QQ-B-575C
AMENDMENT 1
1 April 1997

FEDERAL SPECIFICATION

BRAID, WIRE (COPPER, TIN COATED, OR SILVER COATED, TUBULAR OR FLAT)

This amendment forms a part of QQ-B-575C, dated 22 September 1993, and is approved for use by all Departments and Agencies of the Department of Defense.

1.2.1 Federal Part or Identifying Number (PIN). PINs shall be in the following form:

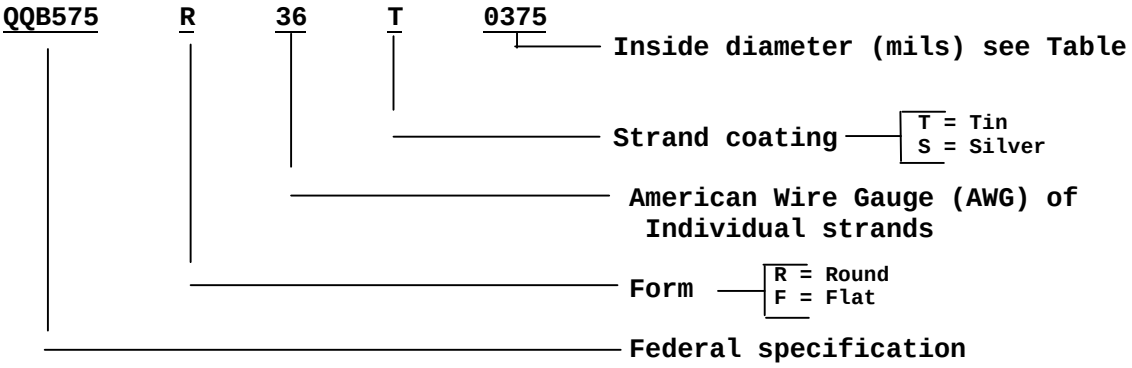
1.2.1 Delete and substitute
